February 1, 2026

Re: Proposed 100-Unit Multi-Family Development at 27 Beecher Road

Responses to the letter by REMA, dated January 20, 2026, to the Inland Wetlands Agency.

Ground and surface water flow pattern after the development.

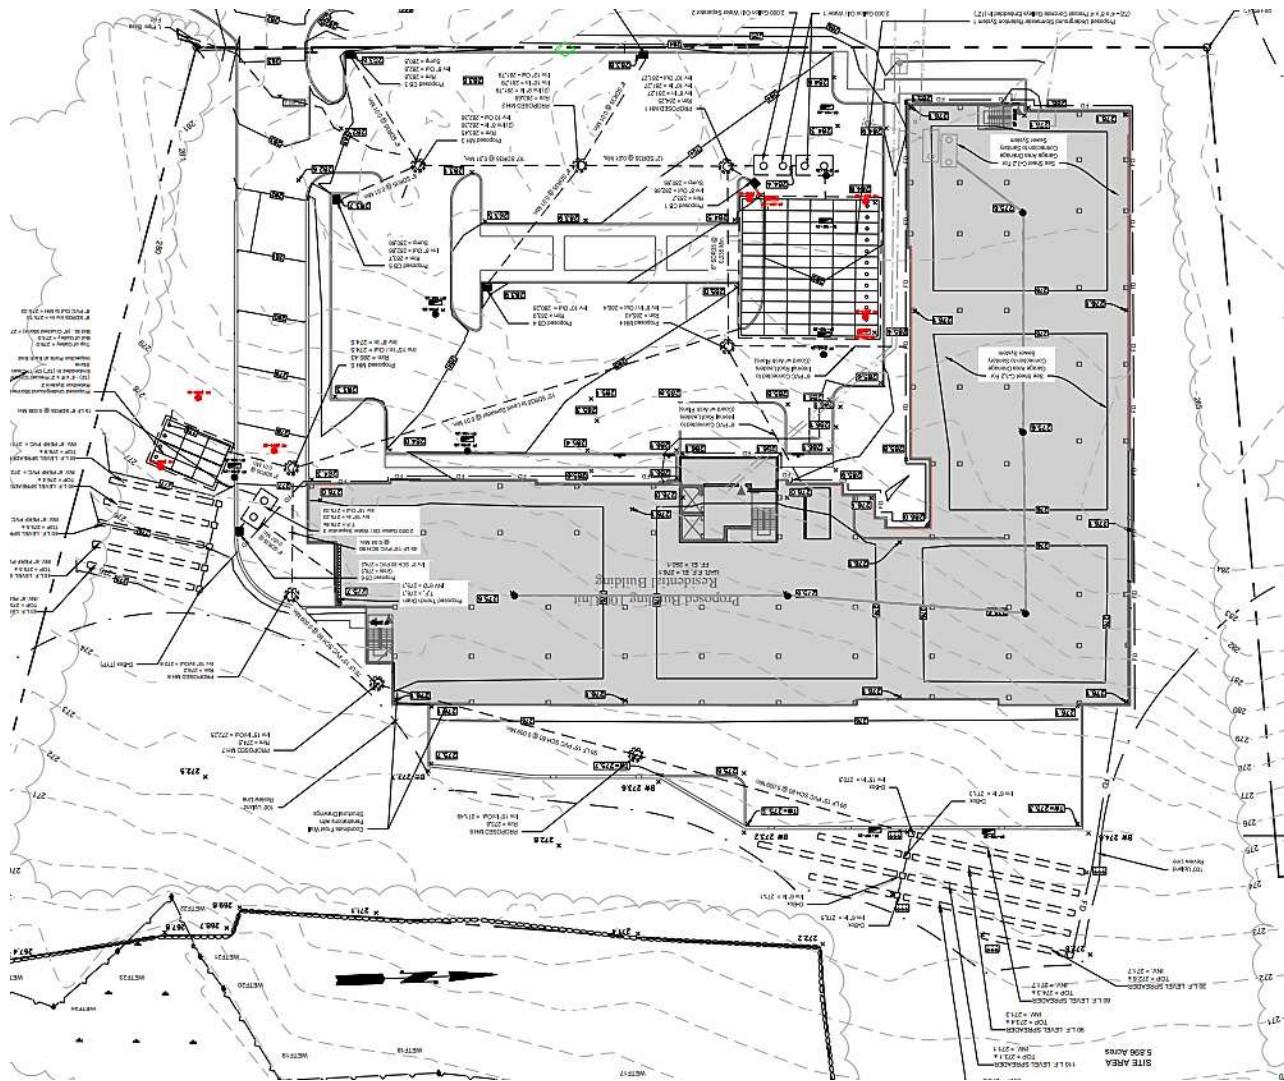
- *The applicant's environmental assessment concludes that no adverse impacts will occur, but does not include a systematic evaluation of changes to surface water flow, shallow groundwater discharge, or wetland hydroperiod. These issues are central to wetland function and require quantitative analysis.*

Groundwater discharge from the front infiltrator will be interrupted by the building, which will be constructed downslope. To prevent a concentration of flow around the southwestern corner, a gravel bed will be installed beneath the slab. As such, the building will act as a large level spreader while allowing the flow to pass beneath the slab. This passage will help evenly distribute the flow before it reaches the wetland. The above measures will ensure there is no change in the wetland hydroperiod.

The existing drainage pattern map was provided in the environmental assessment report for reference. Comparing the two indicates that there will be no changes to wetland hydrology or to the uniformity of feeding the wetland edge. In the diagram above, the darker blue arrows show groundwater flow, while the light blue arrows indicate surface flow.

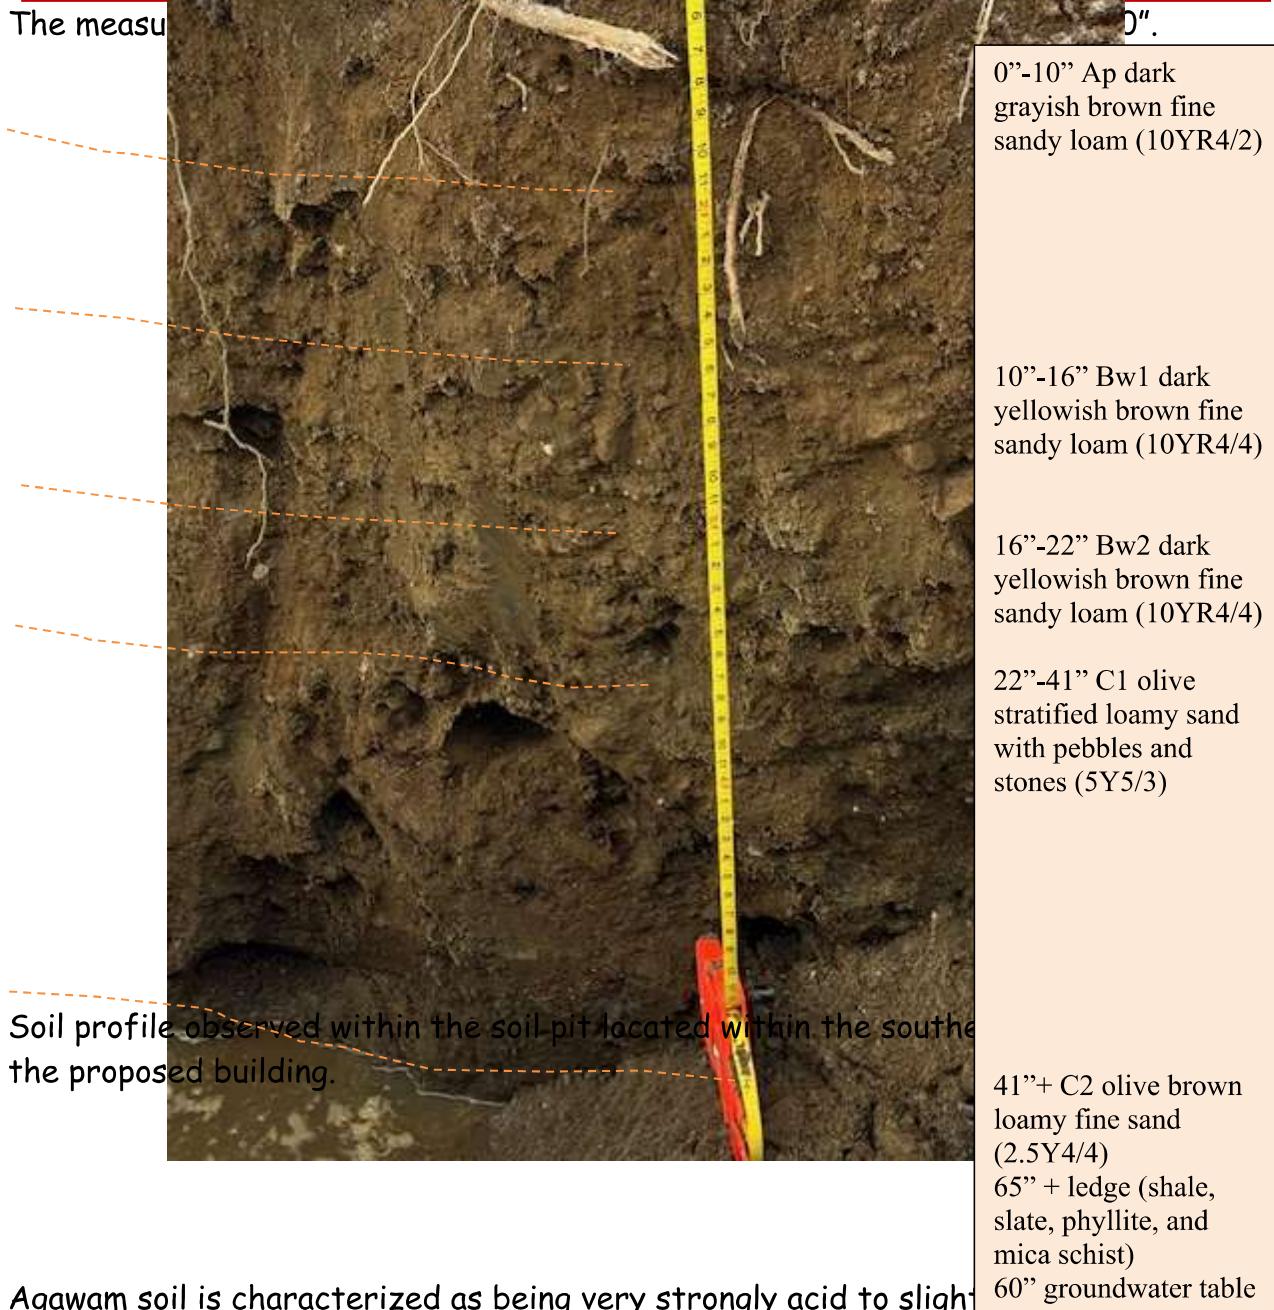
5.2 Soil Characteristics and Subsurface Conditions

The glacial meltout till soils underlying the site are not underlain by gneiss, as stated, but by the Wepawaug Schist formation, consisting of medium to finegrained schist or phyllite (see Figure B, attached).

While the Wepawaug is primarily a schist or phyllite (composed of quartz, muscovite, plagioclase, and biotite), it contains granitic/gneissic intrusions in the region. The Wepawaug Schist in the Woodbridge, CT area is strongly associated with felsic igneous intrusions and neighboring gneissic units, formed primarily during the

Deep soil pits excavated at both lower corners of the building revealed metamorphic rocks with varying degrees of metamorphism. Shale was found at the top, with slate, phyllite, and mica schist in the deeper portions. The ledge formation was soft and easily broken by the excavator. The glaciofluvial outwash contained rounded stones and pebbles consisting of gneiss, granite, and pegmatite. The Agawam soil series was found over the outwash.
